Groundwater Application Review Summary Form

Application # G- 18793 re-review

GW Reviewer Travis Brown Date Review Completed: 5/11/2023

PUBLIC INTEREST REVIEW FOR GROUNDWATER APPLICATIONS

Diagram of Commingling Basalt Wells

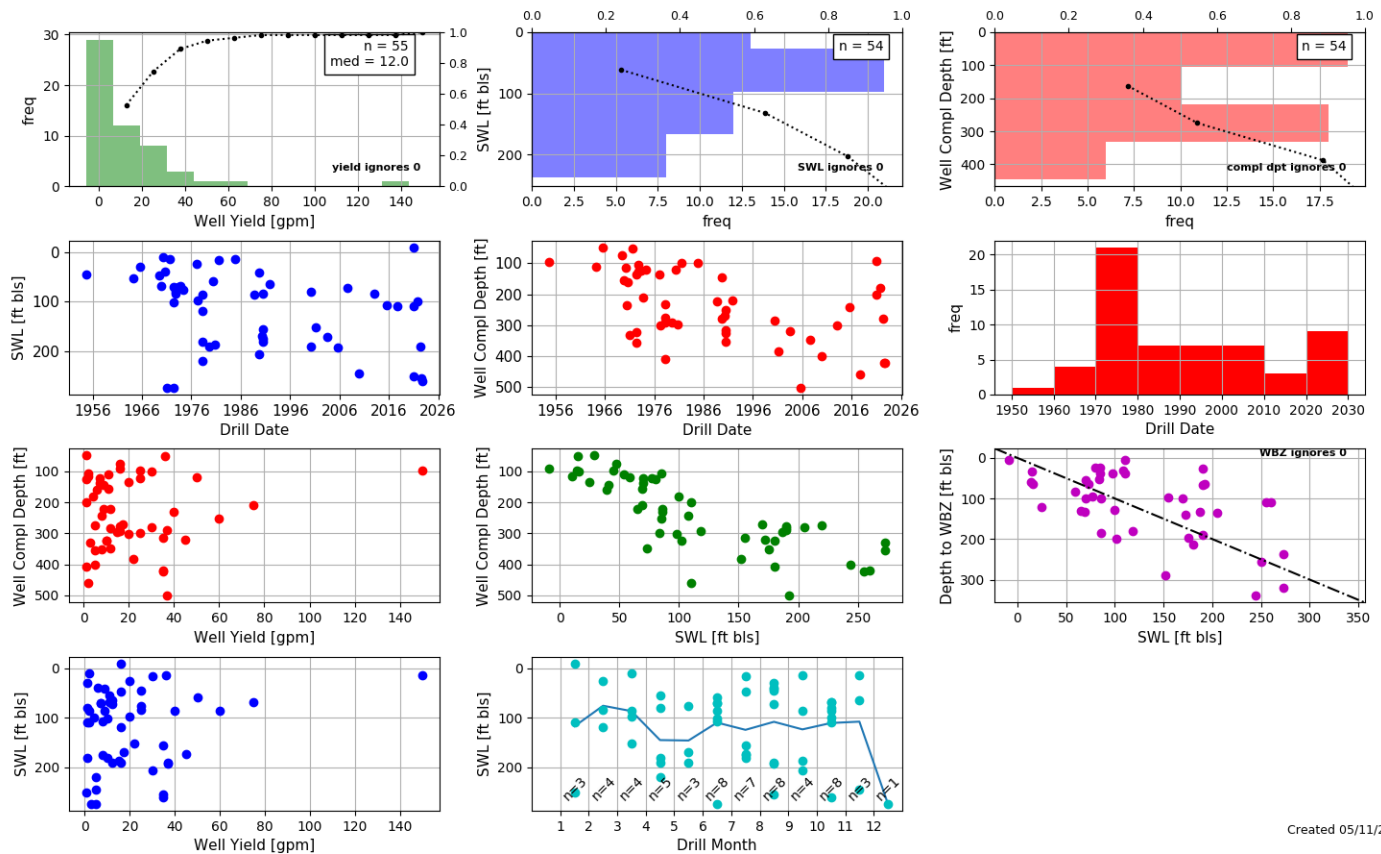
Constructing a well that is open to multiple water-bearing zones with distinct water level heads can commingle multiple aquifers (see diagram from Foxworthy, 1970 at end of review). When the pump is off, water migrates through the well bore from an aquifer of higher pressure to an aquifer of lower pressure. Over time, this can depressurize the aquifer and exacerbates water level decline. Well construction conditions are specified to protect the resource and other existing users.

Basis for aquifer confinement evaluation: Based on the well log for the applicant's well (MARI 4111) the driller encountered water from 98 to 313 feet, with a static water level of 155 feet. Based on other well logs in the area (MARI 4180 and MARI 54020) one would expect confined conditions with static water levels rising to some extent above the zone at which the water was encountered. It appears that this well is (or at least was at the time of construction) open to water-bearing zones above the main confined aquifer (see diagram from Foxworthy, 1970 at end of review).
